GMU Reference: 12027

16 November 2012

**Re:** Summary of issues and urban design review  
**Application No.:** DA 12/28389  
**Property:** 7 Deane & 1-3 Marmaduke Street  
Burwood  
**Proposal:** Proposed Mixed Use Development

Diagram showing the proposed alternative residential communal space at level 4 (adapted from landscape plan 12-2582-L02)

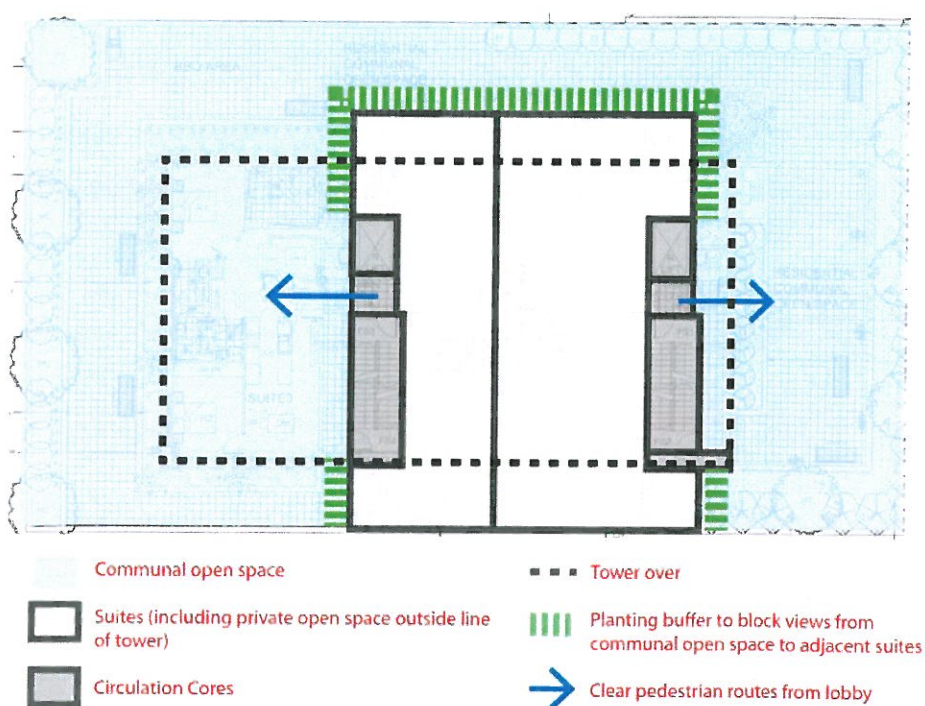
The proposal has responded positively to our suggestion to set back levels 4-6 in order to reduce the perception of a stepping form. Unfortunately, this has led to a detrimental change in the provision to communal open spaces within the design. We are concerned that the present design of communal open spaces (for residential uses on Level 4 and commercial spaces on Level 1) does not present spaces which are large enough to incorporate a variety of uses (including gathering spaces for groups of residents) and also are likely to cause amenity concerns with regard to the adjacent serviced apartments which they are not well screened from.

The diagram below shows our suggested approach to the communal open space located on Level 4, which recommends removing one commercial suite at this floor (Suite 3). Although the adjacent commercial suites and overshadowing of much of the communal open space by the tower above are not ideal, we believe this approach has many advantages such as allowing for larger gatherings and reducing the amenity impact on neighbouring commercial suites. Ideally the communal open space should have a higher floor to ceiling height above the suggested area instead of Unit 3 for better solar penetration and overall amenity, unless sufficient solar access is demonstrated under the current height. We would also like to ensure that access from lift lobbies to the main area of communal open space is direct and does not require circuitous routes (as in the existing scheme). We suggest rearranging the present serviced apartment communal open space on Level 1, as it does not provide a suitable space for communal uses and would be better used as private open space for the adjacent serviced apartment suites.

Diagram showing an alternative treatment to the northern façade (adapted from DA-1017)

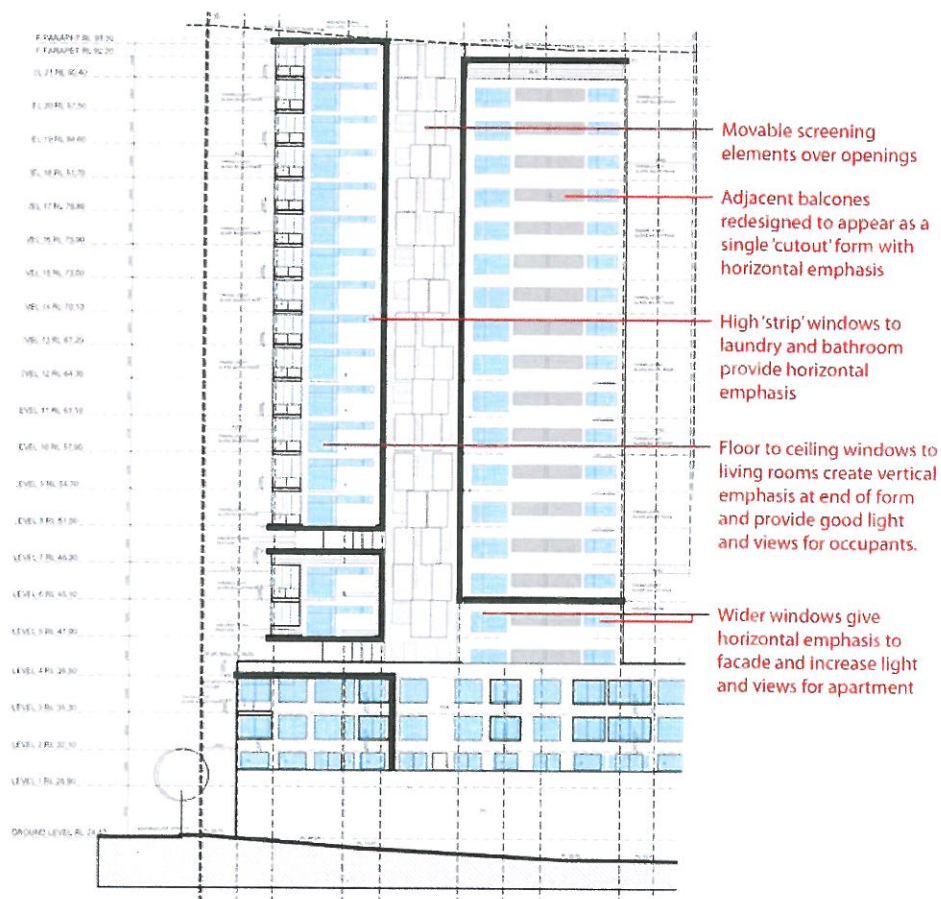
With regards to the tower's façade articulation, the proposal has provided some changes from the previous drawing set, however it is GMU's opinion that it has not changed significantly enough to alleviate our previous concerns (see comments for the June 2012 scheme). We remain concerned with the visual impact of numerous and repetitive openings (same size and configuration of window), lack of negative space and an excessive ratio of openings to solid.

Examples of alternative design approaches to both the northern and eastern facades of the tower form are shown below. These are based on diagrams shown in our comments for the June 2012 scheme and are intended to show how small changes to the current design (including changes in window size, arrangement and articulation) could create a visually stronger façade and also improve the amenity of occupants.

- reducing the number of openings by combining windows servicing the same space;
- introduction of screening, fenestrations or materials over selected vertical segments to create the illusion of negative space;
- redesign of window groupings to relate more closely to the uses behind them (e.g. windows to bathrooms, laundries and bedrooms may not need to be full height);
- a greater variety of window shapes could be used (e.g. through the use of 'strip' windows which are long but narrow in height);
- windows and other articulation elements could be redesigned to create a horizontal or vertical emphasis;
- introduction of further recesses along the façade; and
- exterior shading devices could be carefully introduced.

*Diagram showing an alternative treatment to the eastern façade (adapted from DA-1018)*

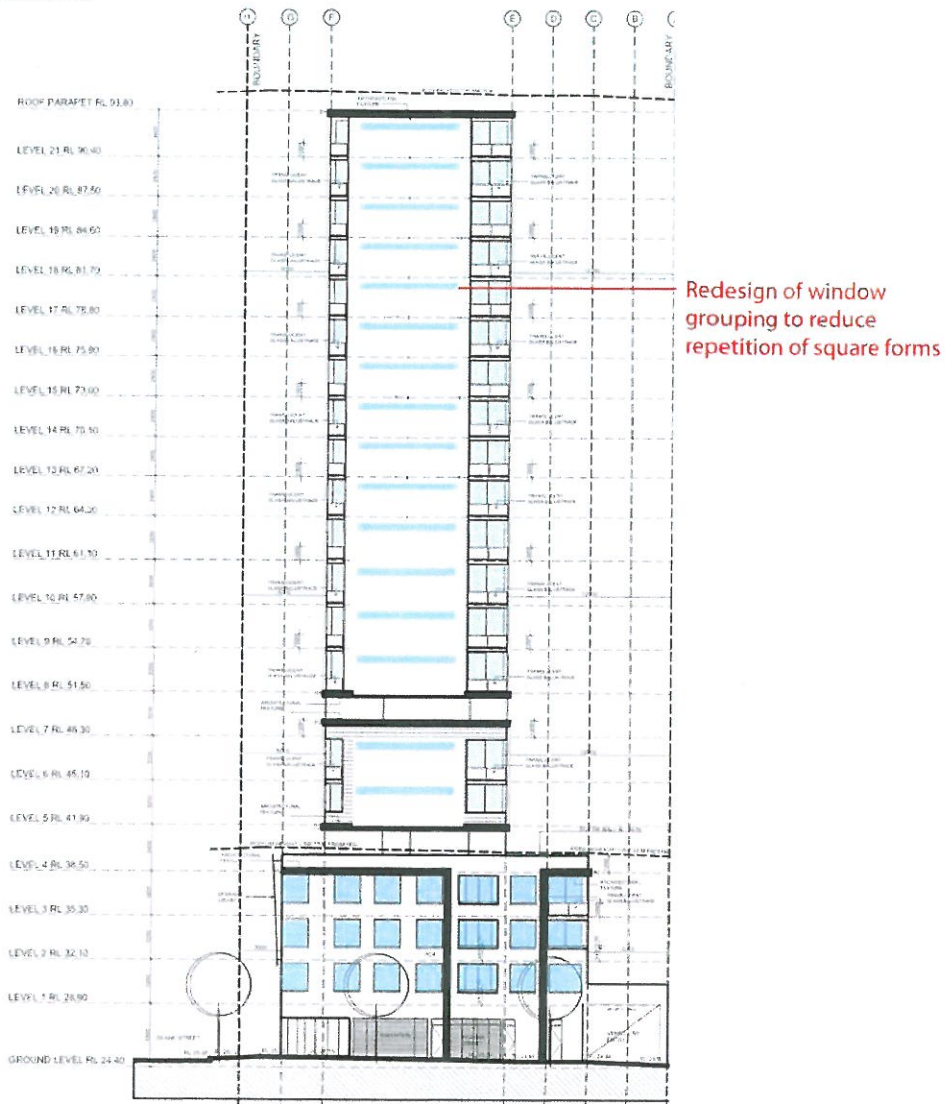
While some changes have been provided to the eastern elevation, the following is another alternative for the Applicant's consideration.
